Docket Item # 13  
BAR CASE # 2006-0281

BAR Meeting  
January 17, 2007

**ISSUE:** After-the-fact approval of Demolition and Permit to Demolish  
**APPLICANT:** Boyd Walker  
**LOCATION:** 200 Commerce Street  
**ZONE:** CL/Commercial

**Figure 1 - Before demolition**

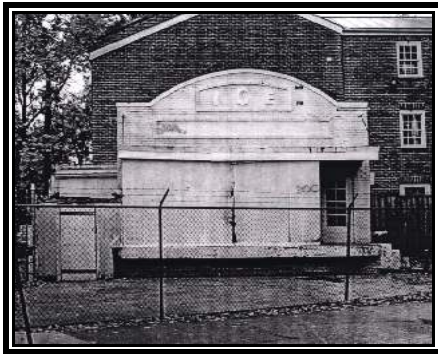
The applicant is requesting after-the-fact approval of a Permit to Demolish portions of the Ice House building at 200 Commerce Street. Prior to making application, the applicant removed a framed enclosure on the front loading dock of the Ice House and removed the projecting canopy over the front loading dock.

The applicant did not contact BAR Staff or Code Enforcement regarding the decision to remove the enclosure on the front loading dock and the canopy. Therefore, staff was unable to make any professional determination of the historic integrity of these features of the building.

Staff believes that the Ice House itself meets criteria #'s 4 and 6. As stated previously, the Ice House is representative of a small scale industrial building from the first half of the 20<sup>th</sup>-century. In the opinion of staff, the canopy was an original character-defining feature of the building and

its loss has diminished the integrity of the building. It is unclear from available records when the front loading dock was partially enclosed with the framed enclosure.

1. That the applicant replace the demolished canopy to match the original canopy in respect to size and proportions, structure, and materials,
2. That any remaining features such as the support chains and rings/bolts be retained, and
3. That the applicant must obtain a building permit from Code Enforcement.
